Access Compliance Report

Public Rights-of-Way

Intersection ID: 44419	Main Street: ARDREY_KELL_RD	Cross Street: PROVIDENCE_RD	Location: SW
ADA ID: B872E3D51464	Ramp Type: Para	Initial Pass/Fail: Fail	Overall Compliance: No
Severity Score: 25			
Codes/Mitigation Info/Possible Solution		Field Measurements/Component Compliance

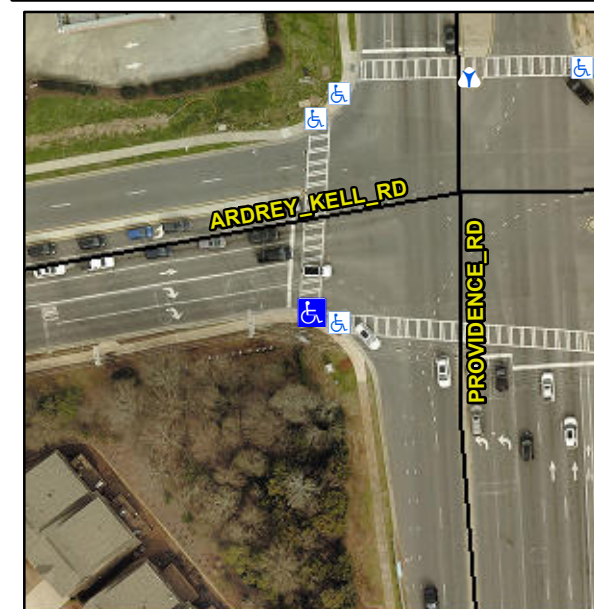
RT RP < 5%

R304.3.2

Compliance	Description	Data	Compliance	Description	Data
N/A	Ramp Length LT (in)	83.0	N/A	Ramp Length RT (in)	72.0
Yes	Ramp Width LT (in)	60.0	Yes	Ramp Width RT (in)	59.0
No	Ramp Slope LT (%)	13.4	Yes	Ramp Slope RT (%)	2.0
Yes	Ramp XSlope LT (%)	1.1	Yes	Ramp XSlope RT (%)	0.7
N/A	Landing Length (in)	N/A	N/A	DWS Provided?	N/A
N/A	Landing Width (in)	N/A	N/A	DWS Contrast?	N/A
N/A	Landing Slope (%)	N/A	N/A	DWS Length (in)	N/A
N/A	Landing X Slope (%)	N/A	N/A	DWS Full Width?	N/A
N/A	Landing Curb? (Y/N)	N/A	N/A	DWS Offset (in)	N/A
N/A	Shared Landing?	N/A			
N/A	Gutter Ponding?	N/A	N/A	Gutter Slope (%)	N/A
N/A	Gutter Lip Ht (in)	N/A	N/A	Gutter X Slope (%)	N/A
N/A	Painted X Walk1?	Yes	N/A	Painted X Walk2?	N/A
	X Walk 1 Direction	To N		X Walk 2 Direction	N/A
N/A	X Walk 1 Width (in)	112.0	N/A	X Walk 2 Width (in)	N/A
	X Walk 1 Slope (%)	0.6		X Walk 2 Slope (%)	N/A
	X Walk 1 X Slope (%)	5.3		X Walk 2 X Slope (%)	N/A
N/A	Ramp inside XWalk1?	Yes	N/A	Ramp inside XWalk2?	N/A

Remove & Replace Entire Ramp.
